CONTRACT CHANGE ORDER NO. _____
SHEET ___ OF ___

MARK	DATE	DESCRIPTIONS	BY	CH'D	CCO#
2	04/08/11	SUSPENSION CABLE MISCELLANEOUS DETAILS	GB	MN	185
1	01/28/11	MISCELLANEOUS CABLE SYSTEM DETAILS	GB	MN	37S1

SAN FRANCISCO OAKLAND BAY BRIDGE
EAST SPAN SEISMIC SAFETY PROJECT
SELF-ANCHORED SUSPENSION BRIDGE
(SUPERSTRUCTURE & TOWER)
EAST CABLE ANCHORAGE "E" LINE LAYOUT NO. 2

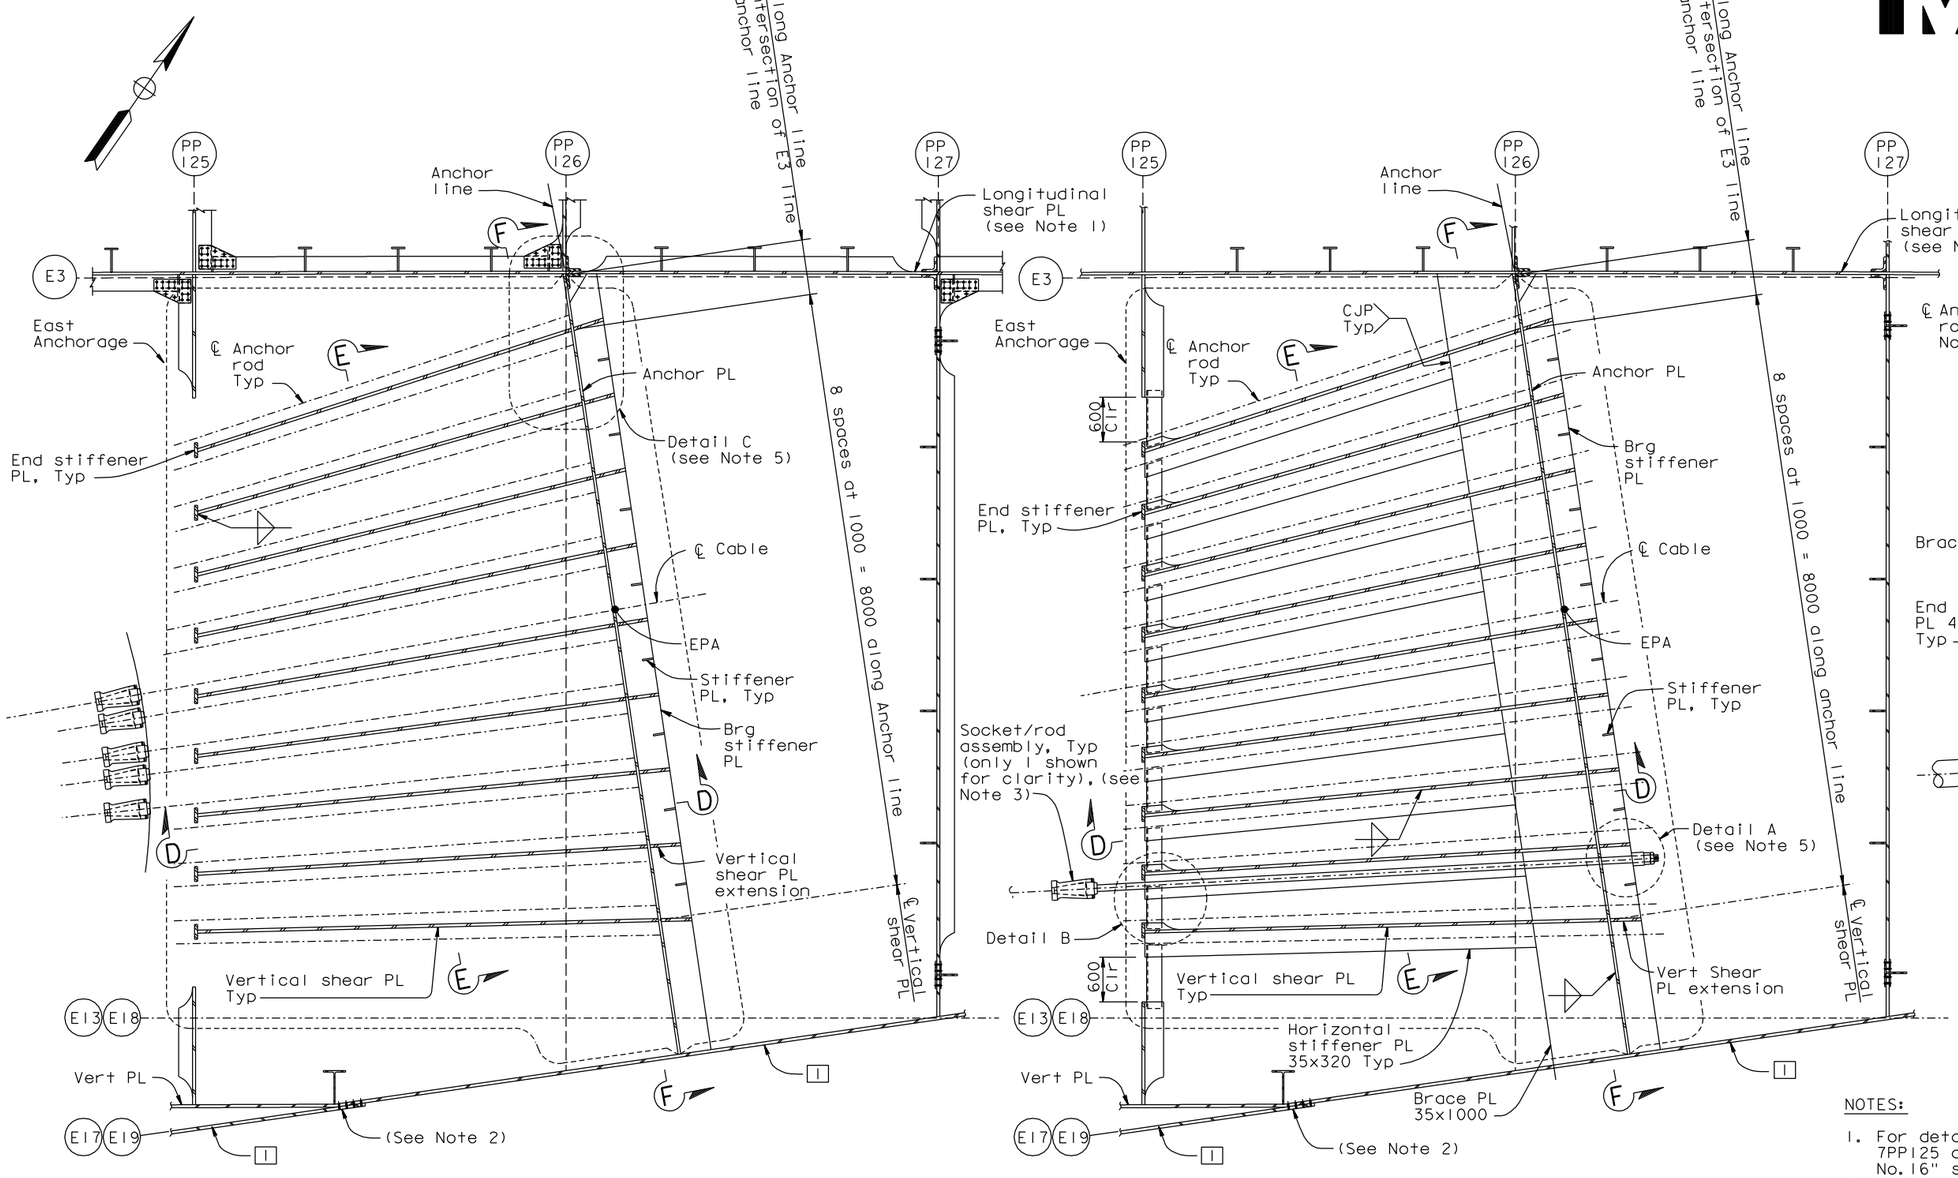
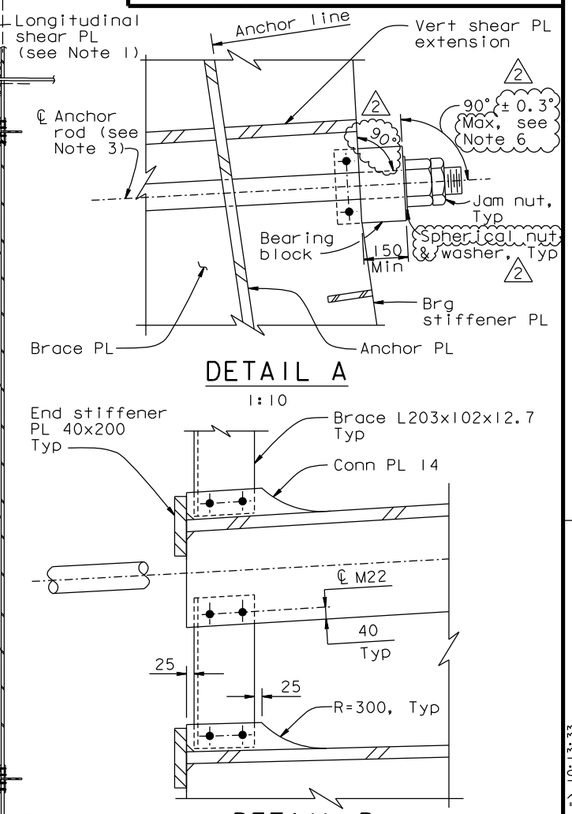
6. The bearing blocks shall be aligned with the bearing stiffener plates. The angle between the bearing block and the anchor rod may vary (up to 90° ± 0.3° Max) due to the averaging of the bearing stiffeners orientation across each row of anchors.

EAST CABLE ANCHORAGE "E" LINE LAYOUT NO. 3

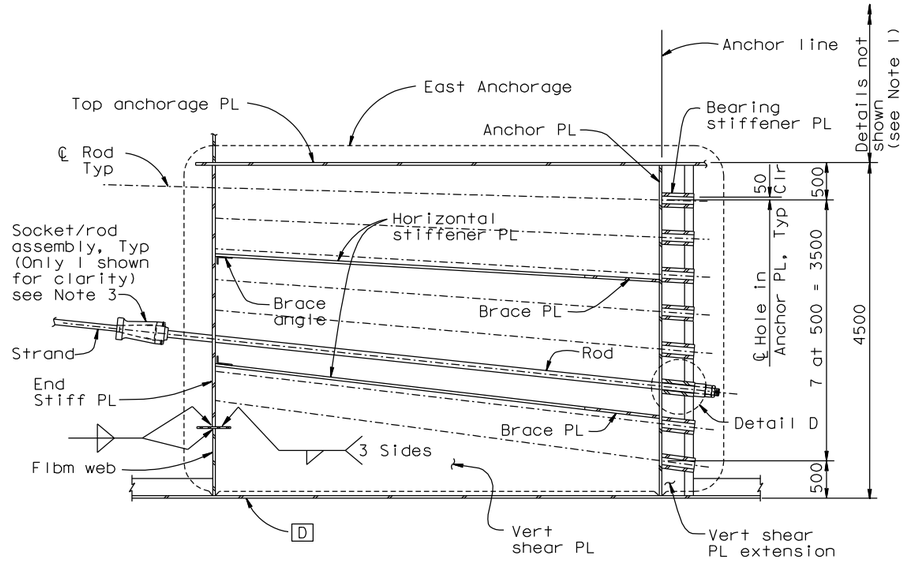
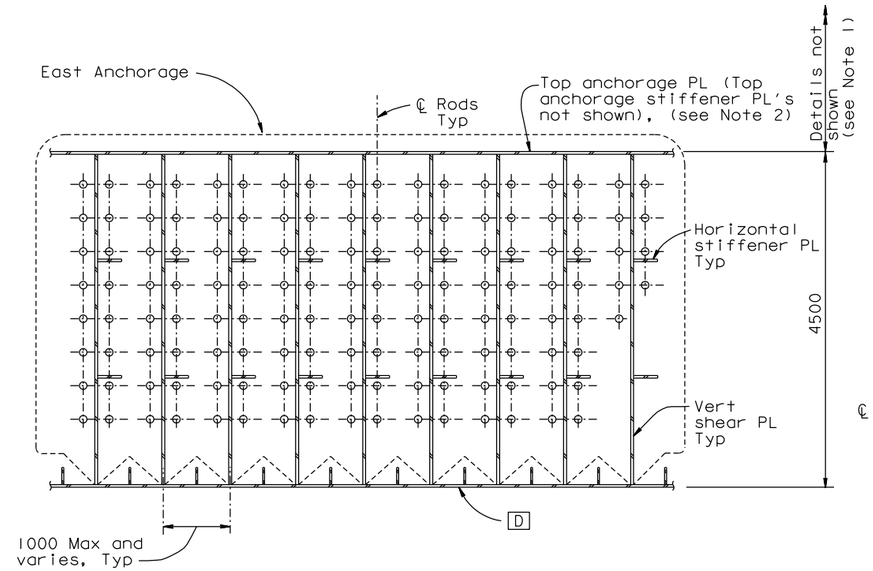
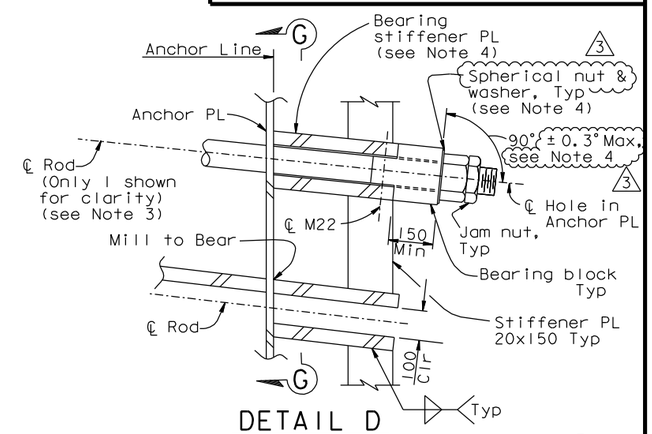
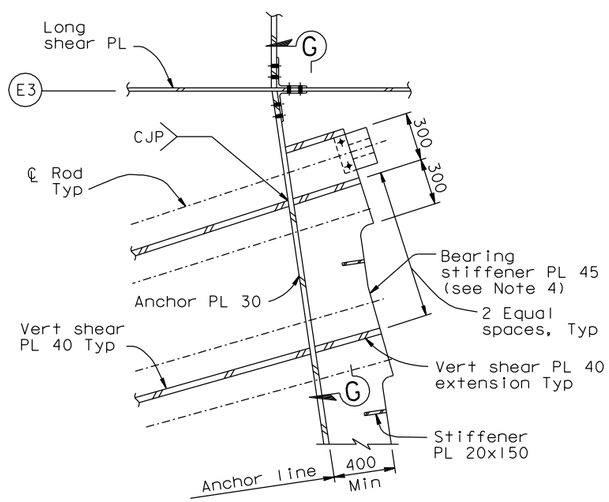
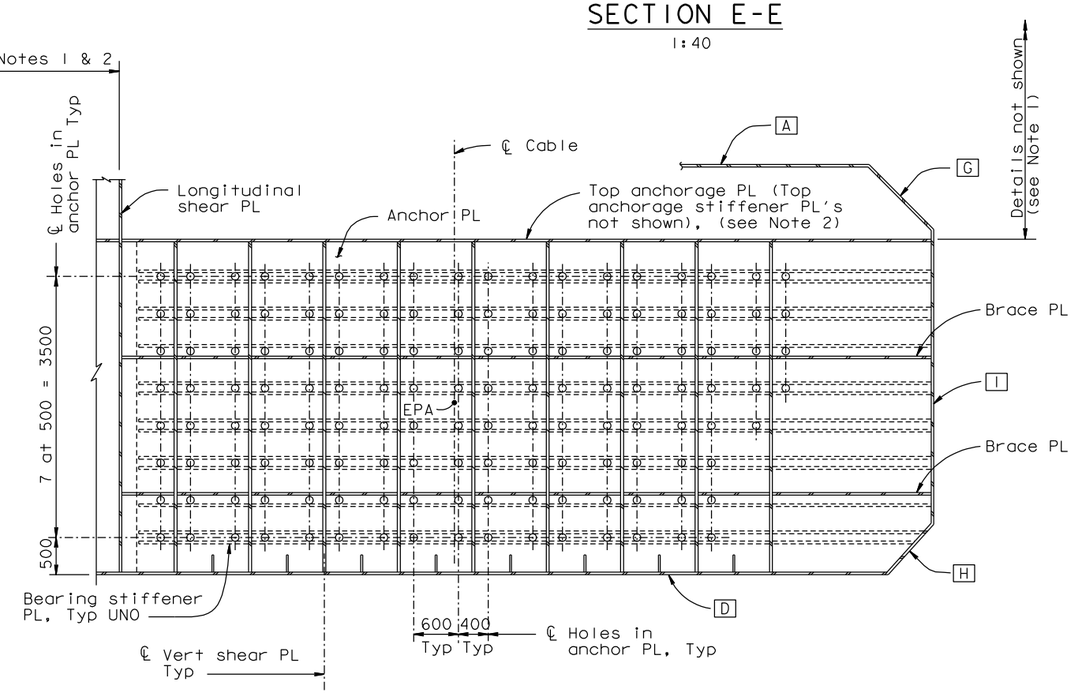
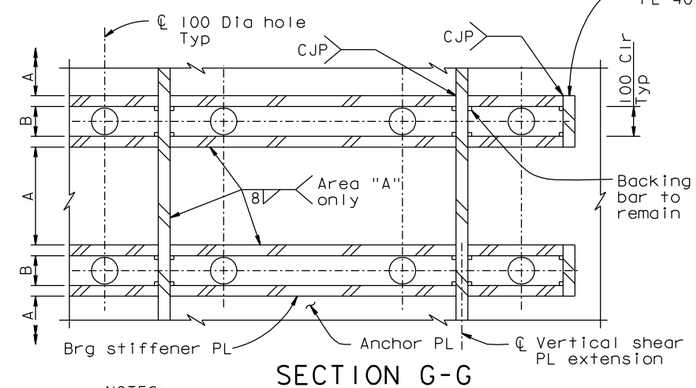
1. For girder details not shown, see "Girder At East Transition" sheets.
2. For top anchorage plate details not shown, see "Crossbeam at East Anchorage" and "Girder At East Transition" sheets.
3. For strand socket, transition anchor rod and bearing block details, see "East Cable Anchorage Details" sheet.
4. Bearing stiffener plates shall be machined to level the bearing block under the nut. Washers may be beveled to 1°. The installation tolerance for the bearing block/anchor rod angle is ±1°. Also see Note 6 on "East Cable Anchorage "E" Line Layout No. 2" sheet.

SAN FRANCISCO OAKLAND BAY BRIDGE
EAST SPAN SEISMIC SAFETY PROJECT
SELF-ANCHORED SUSPENSION BRIDGE
(SUPERSTRUCTURE & TOWER)
EAST CABLE ANCHORAGE "W" LINE LAYOUT NO.2

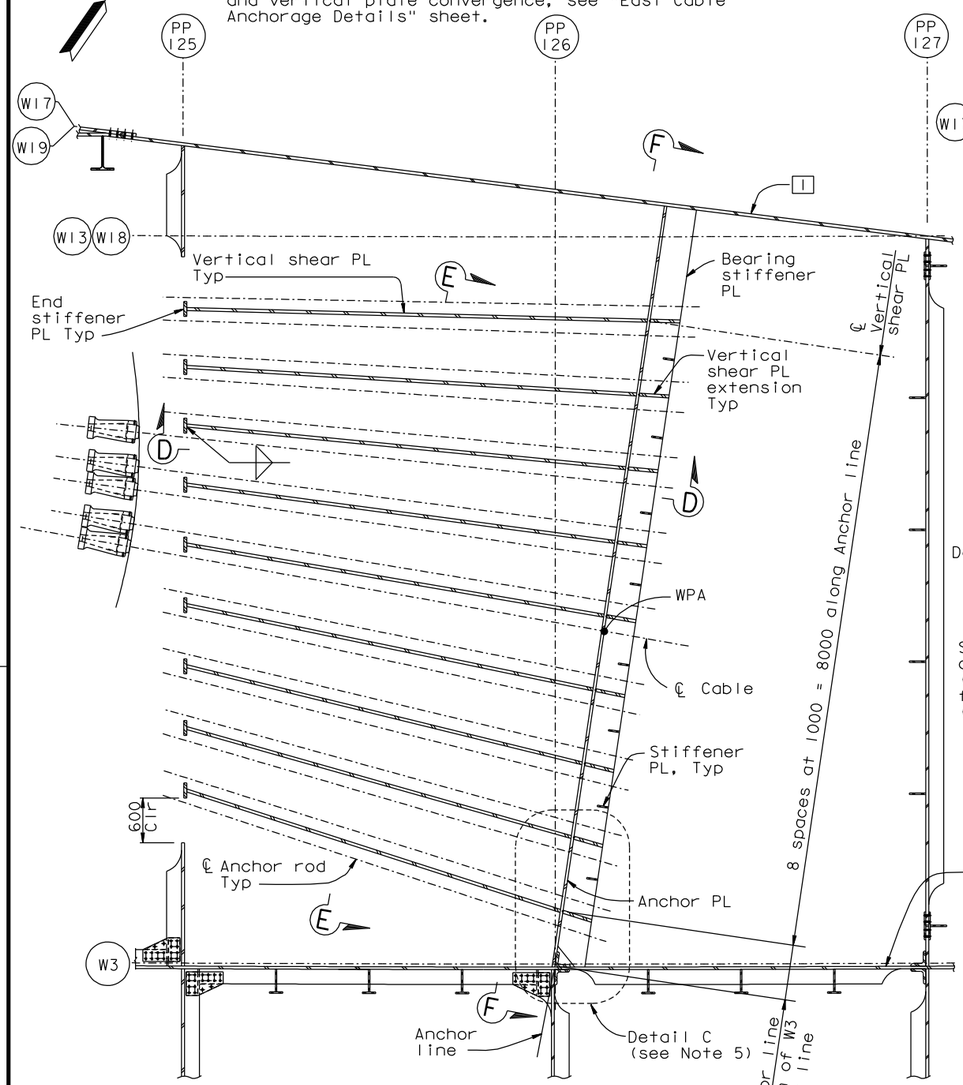
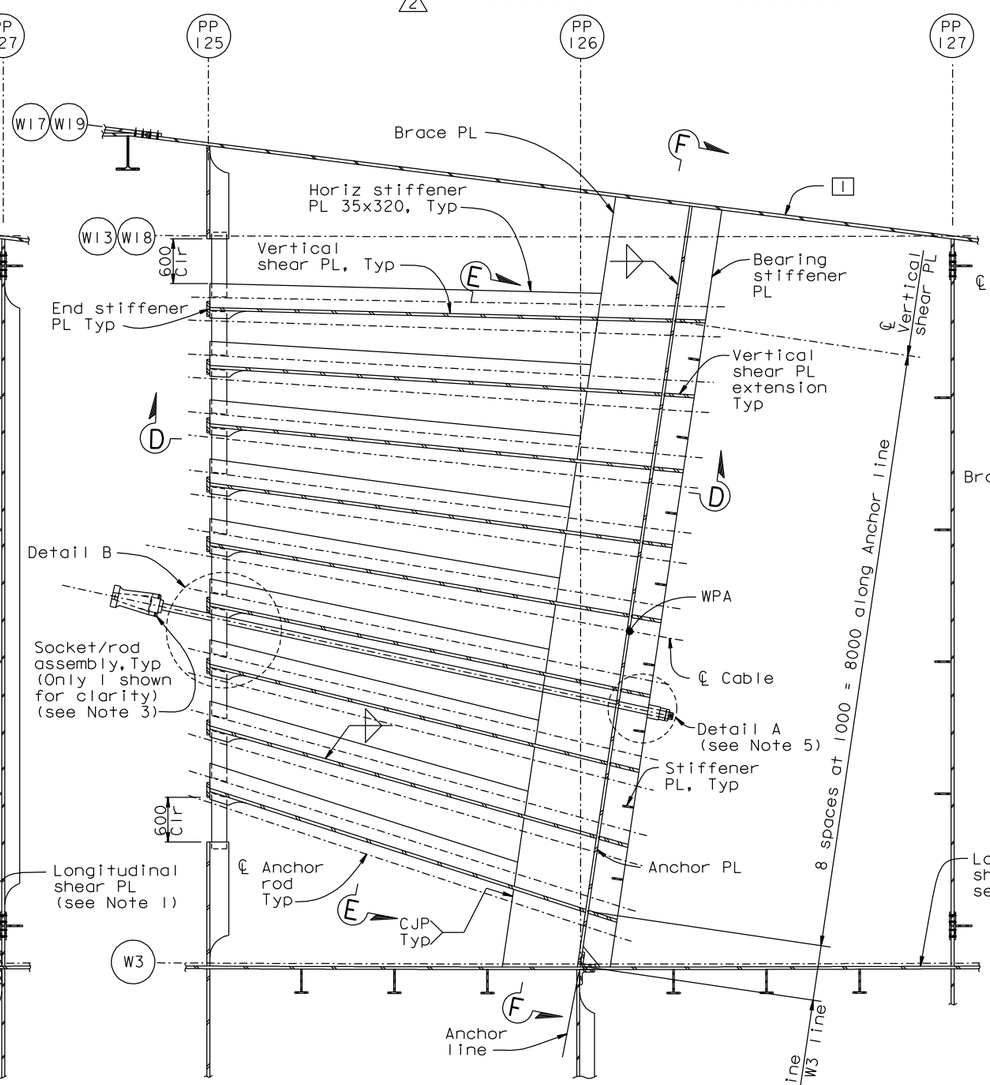
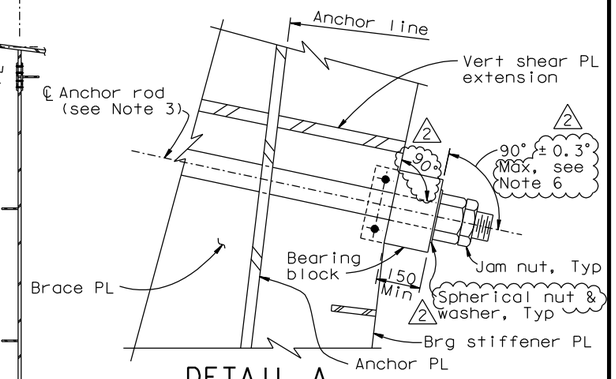
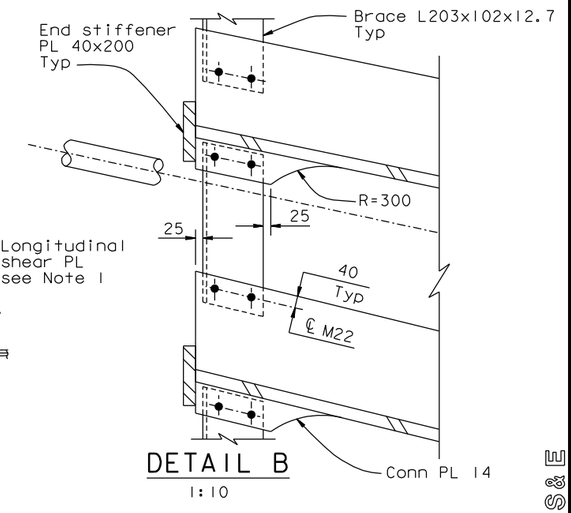
1. For details of longitudinal shear plate between PI25 and PP127, see "Girder At East Transition No.16" sheet.
2. For details of splice connection at girder plate and vertical plate convergence, see "East Cable Anchorage Details" sheet.
3. For strand socket and anchor rod details, see "East Cable Anchorage Details" sheet.
4. For Detail C and Sections D-D, E-E and F-F, see "East Cable Anchorage "W" Line Layout No.3" sheet.
5. Machining of bearing stiffener not shown in plan view.
6. The bearing blocks shall be aligned with the bearing stiffener plates. The angle between the bearing block and the anchor rod may vary (up to 90° ±0.3° Max) due to the averaging of the bearing stiffeners orientation across each row of anchors. (2)

EAST CABLE ANCHORAGE "W" LINE LAYOUT NO. 3

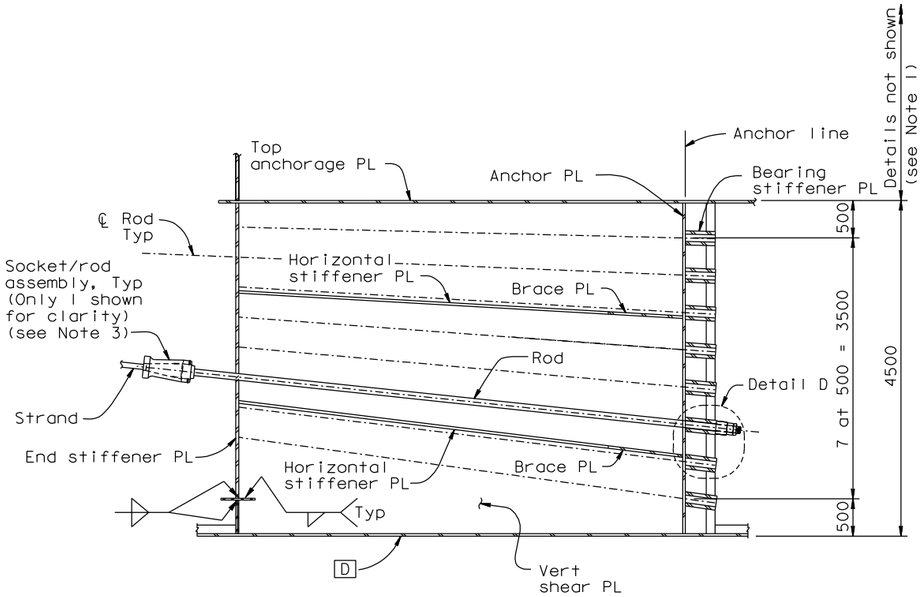
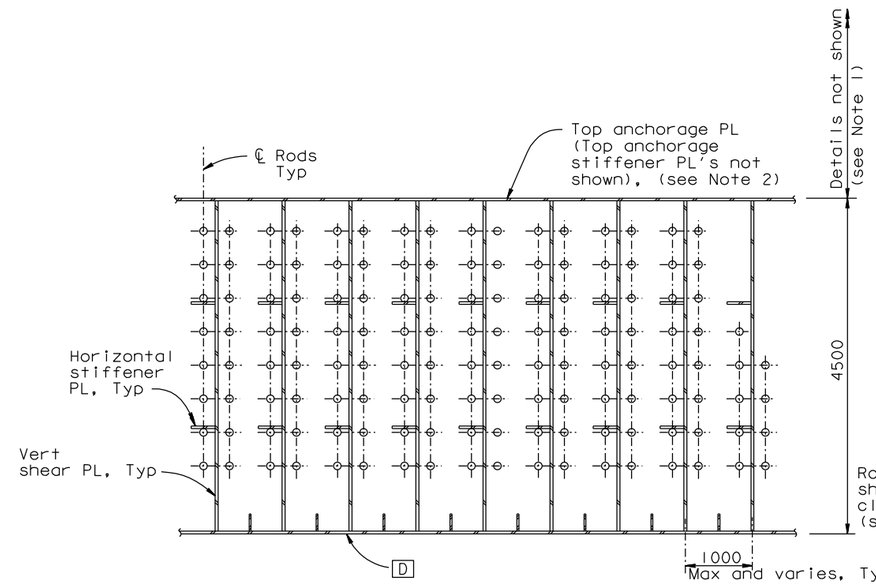
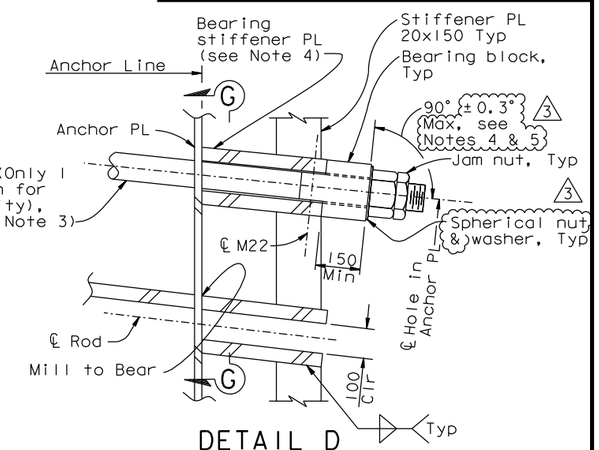
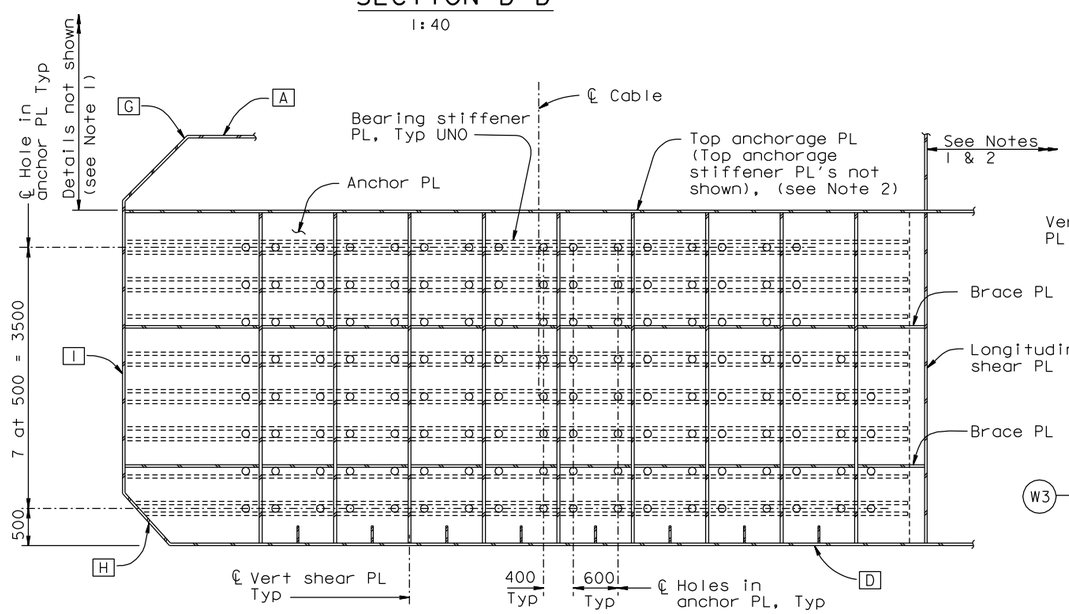
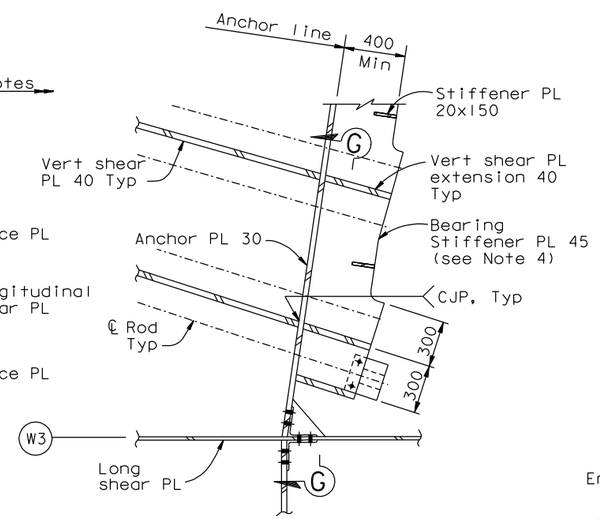
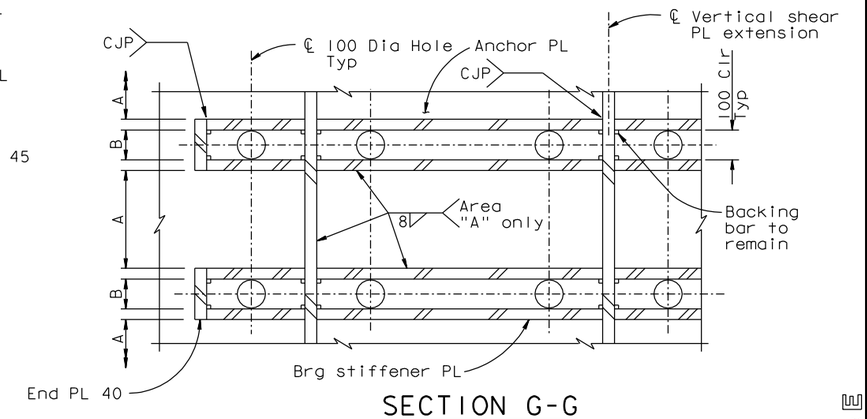
1. For girder details not shown, see "Girder At East Transition" sheets.
2. For top anchorage plate details not shown, see "Crossbeam At East Anchorage" and "Girder At East Transition" sheets.
3. For strand socket, transition anchor rod and bearing block details, see "East Cable Anchorage Details" sheet.
4. Bearing stiffeners plates shall be machined to level the bearing block under the nut. Washers may be beveled to 1°. The installation tolerance for the bearing block/anchor rod angle is ±1°. Also see Note 6 on "East Cable Anchorage "W" Line Layout No.2" sheet.
5. The bearing blocks shall be aligned with the bearing stiffener plates. The angle between the bearing block and the anchor rod may vary (up to 90° ±0.3° Max) due to the averaging of the bearing stiffeners across each row of anchors.
